Office Action Summary	Application No. 10/577,662	Applicant(s) YOKOTA ET AL.	
	Examiner WILLIAM MCCALISTER	Art Unit 3753

DETAILED ACTION

FIG. 5

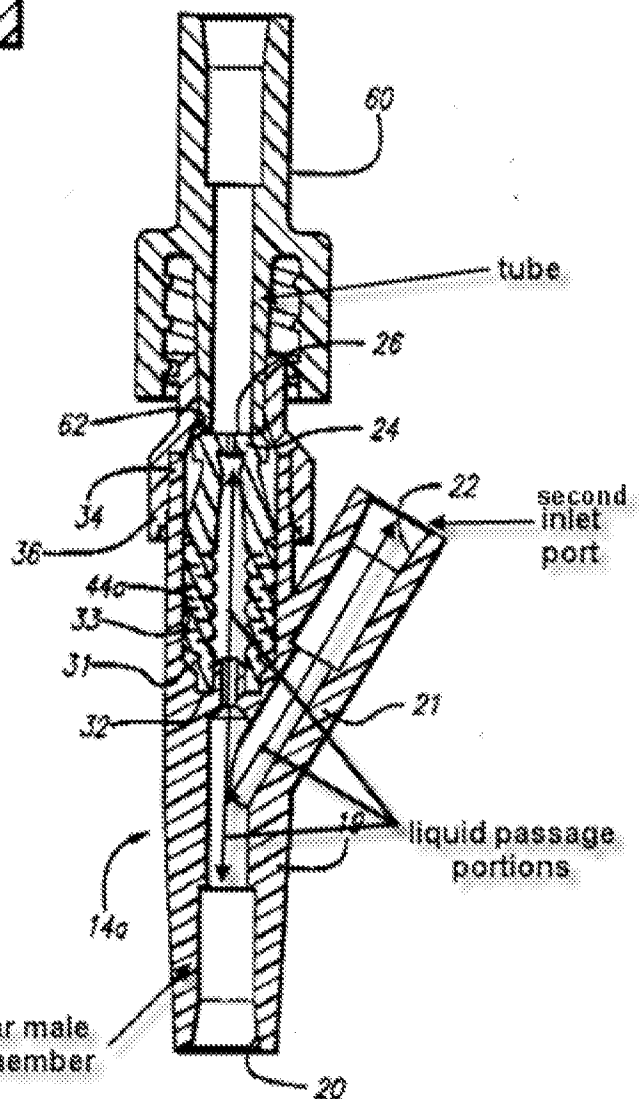
a tubular male joint member (see annotated FIG 5, below);

a liquid passage portion (all interior space through which fluid flows, as illustrated at annotated FIG 5, below) having a liquid passage space defined therein (two generally cylindrical spaces of reduced radius, centered along the axes which define the liquid passage portion) in fluid communication with an interior of said male joint member,

a first female joint port (18, which is a component of the first inlet port) which is capable of receiving a tube (see annotated FIG 5, below); and

Leinsing also discloses a second inlet port (see annotated FIG 5, below), but does not disclose a second valve body and second female joint port connected to this second inlet port. To avoid contamination and reduce the need for cleaning at the second inlet port, it would have been obvious to one of ordinary skill in the art at the time of invention to supplement Leinsing's second inlet port with a second valve body and second female joint port of the same construction as Leinsing's first valve body and first female joint port, to predictably obtain a connector which creates an airtight seal at the connection to either inlet port. (Alternatively, it would have been obvious to one of ordinary skill in the art at the time of invention to provide a second valve and second female joint port, since it has been held that mere duplication of the essential working parts of a device involves only routine skill in the art. *St. Regis Paper Co. v. Bemis Co.*, 193 USPQ 8).

As such, the central line of the first female joint port and the central line of the second female joint port would be skew lines with respect to each other, as claimed. (Merriam-Webster's dictionary also defines the term *skew* as "slanted".)
